Sundry Print Report

Well Name: GEORGE TURPIN

Type of Action: Plug and Abandonment

Attachment to notice of Intention to Abandon

Proposed Wellbore Diagram

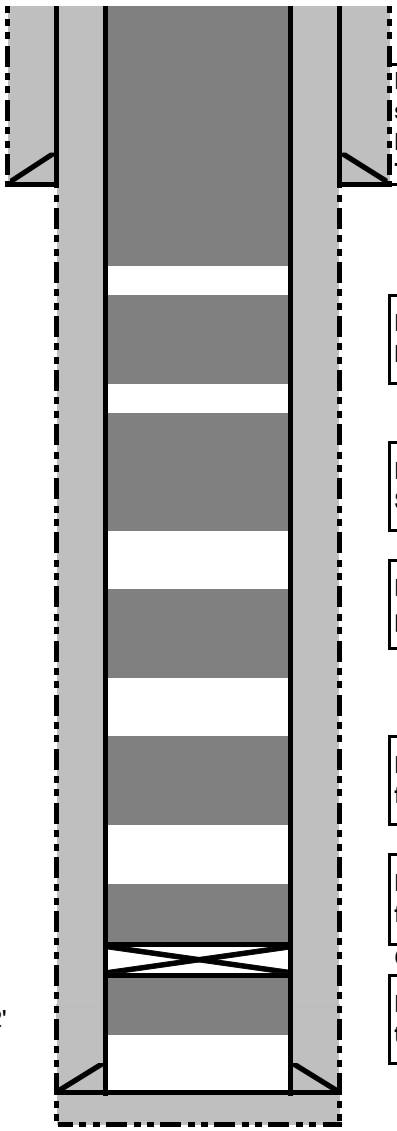
Plug 7: (Ojo Alamo, surface casing shoe, and surface plugs): Spot balanced plug from 313' to surface. Top off casing as necessary.

Plug 6 (Fruiltand and Kirtland): Spot balanced plug from 679-360'.

Plug 5 (Chacra and Pictured Cliffs): Spot balanced plug from 1490-1140'

Plug 4 (Mesa Verde): Spot balanced plug from 1911-1811'.

Plug 3 (Mancos): Spot balanced plug from 3730-3630'.

Plug 2 (Gallup): Spot blind plug from from 4580' to 4550' on top of retainer.

Plug 1: Mix and attempt to place 25 sx through CR into Gallup perfs.

You are also required to place cement excesses per 4.2 and 4.4 of the attached General Requirements.
